INSTRUCTION TO SERVICE

ITS: 5895	
SECTION:	292 Electrical Harnesses
WRITTEN BY:	K. Baziuk
SUBJECT:	Secure Rear Harness in Muffler Compartment.

Figure 2: Location of P-Clamp to be added.

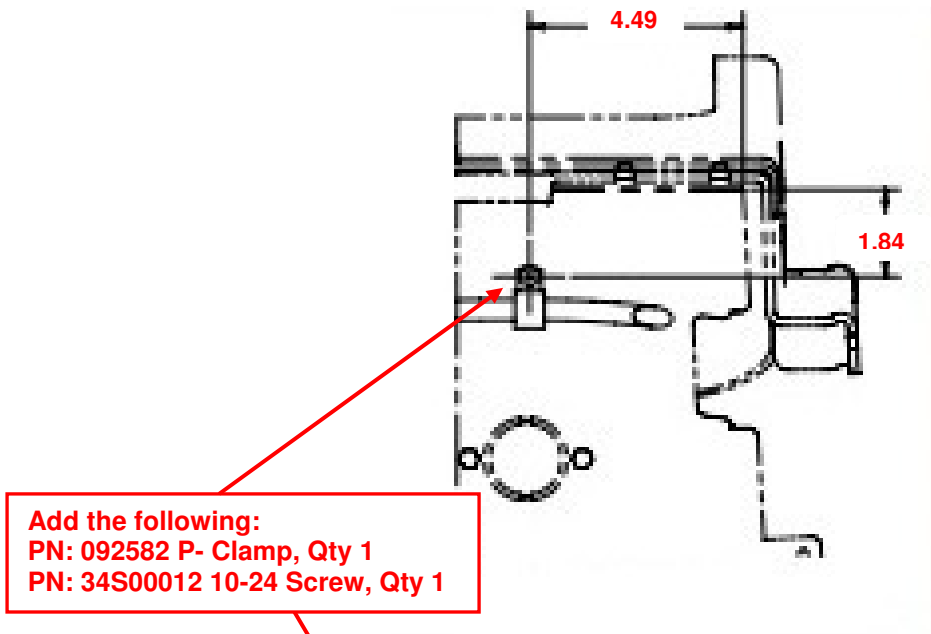
3. Locate existing tapping screw into firewall. See Figure 2.
4. Install P-Clamp PN: 092582 Qty 1 and 10-24 Screw PN: 34S0016 Qty 1, into firewall assembly, See Figure 2.

NOTE: Ensure connector and any slack is placed forward of door hinge, away from muffler compartment.

Figure 3: Final assembly of harness.

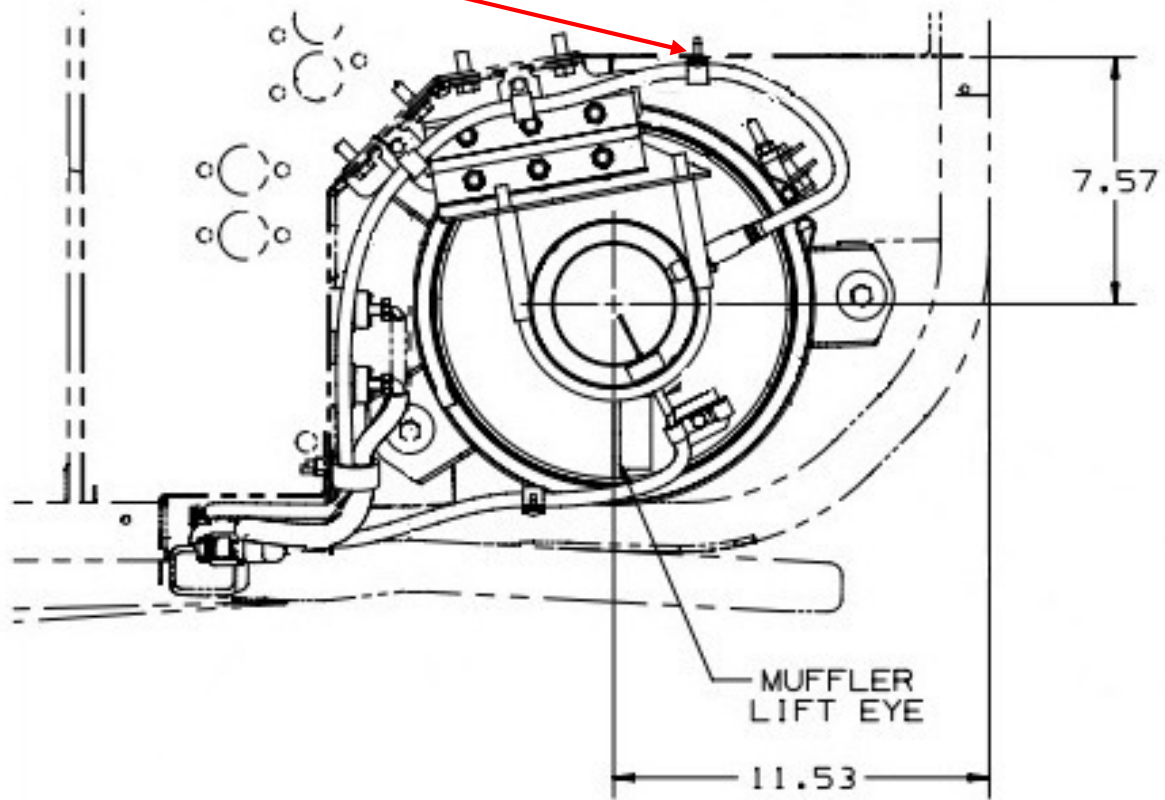
5. Secure harness assembly and tighten all clamps. Refer to figure 4 and 5.
6. Turn the main battery disconnect switch to the “ON” position
